RE: DRAINAGE PLAN FOR PONDEROSA RESERVOIR (G-21/D28)
ENGINEER'S STAMP DATED MAY 3, 1988

To:
Subject: PONDEROSA RESERVOIR NO. 2

Re: Drainage Analysis at Ponderosa Reservoir No. 2
URS Project No. 46801

EXHIBIT A

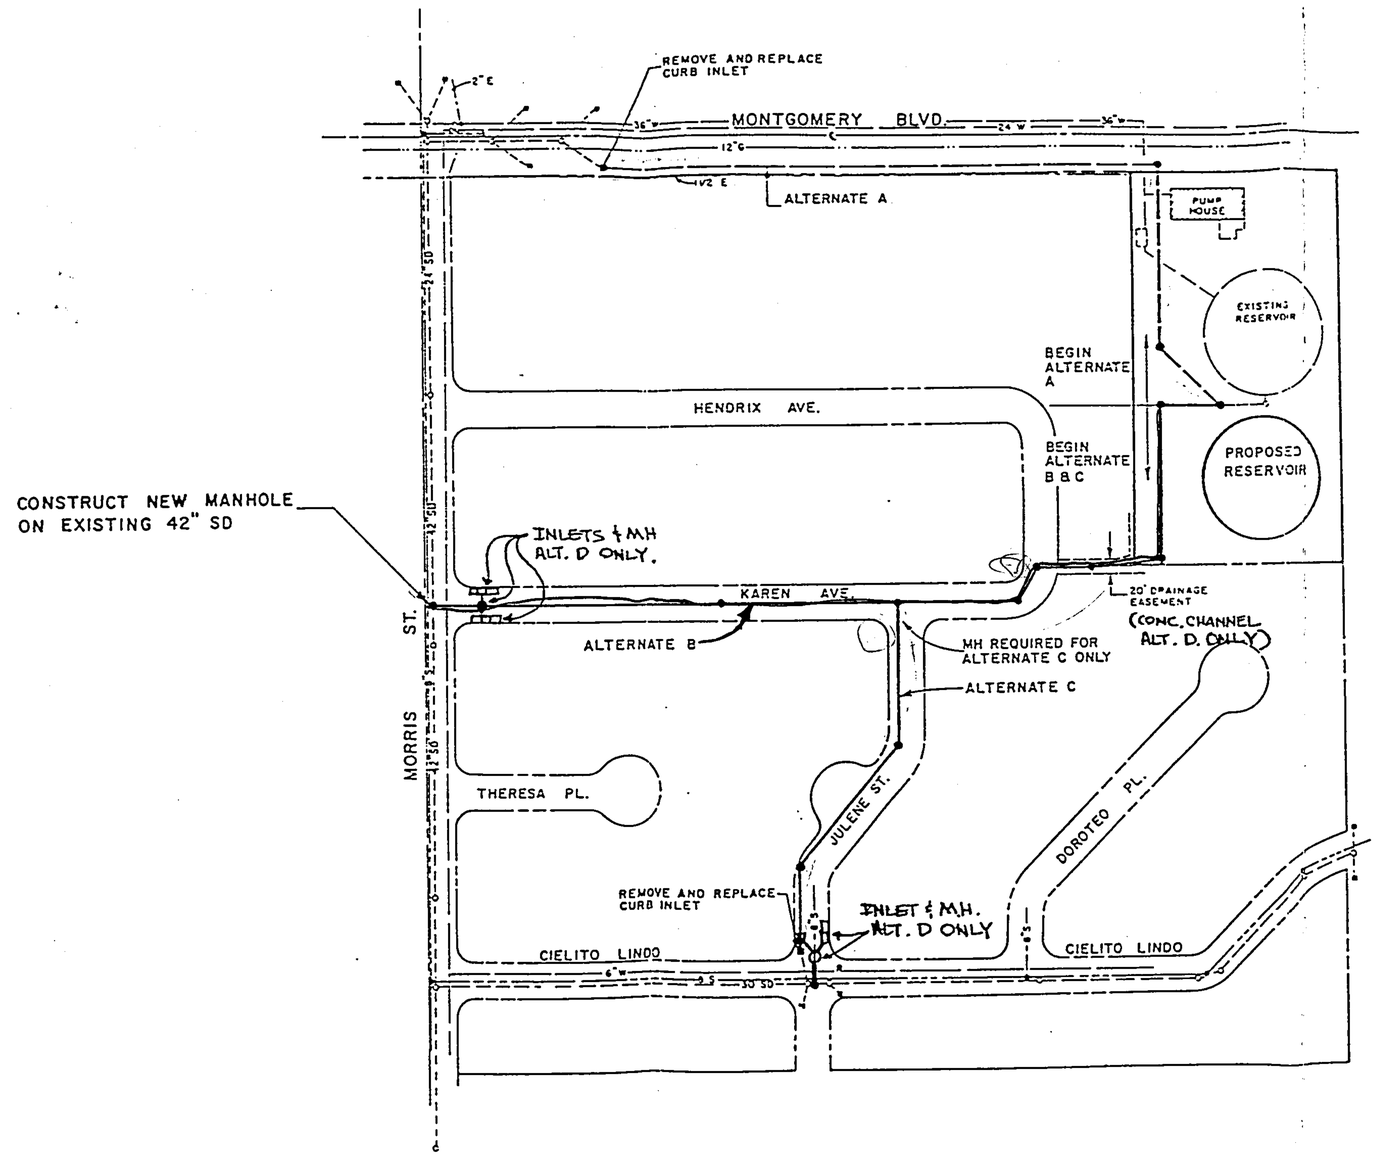
Alternative A proposes to construct a storm drain to Montgomery Boulevard from the well site. However, the storm drain in Montgomery Boulevard has minimal capacity, therefore, the existing storm drain in Montgomery Boulevard would need to be upgraded to handle the additional flows from the site. This alternative is not recommended.

Alternative B proposes to connect a storm drain system to Morris St. The storm drain system in Morris can convey the majority of the flows with the remaining flows being conveyed overland. This is the most attractive alternative given the capacity in Morris Street.

Alternative C is similar to Alternative B in that it proposes to connect to a sorm drain system, however, this connection would be in Cielito Lindo. The difference between the connection in Morris and Cielito Lindo is one of capacity, i.e., Morris has more capacity than Cielito Lindo. In either case, B or C, there exists sufficient capacity for dealing with the 111 cfs.

Alternative D is the least costly, however, this alternative, in my opinion, would overflow into the adjacent property given that this concept does not take into account vehicles that could be parked in the street which would reduce the flow capacity of the treet. Additionally, the proposal to use landscape berms to contain the runoff in the street is not a practical solution given the maintainability and/or lack of permanency of such a structure. A structure such as this would require constant monitoring and maintenance. I do not recommend this alternative.
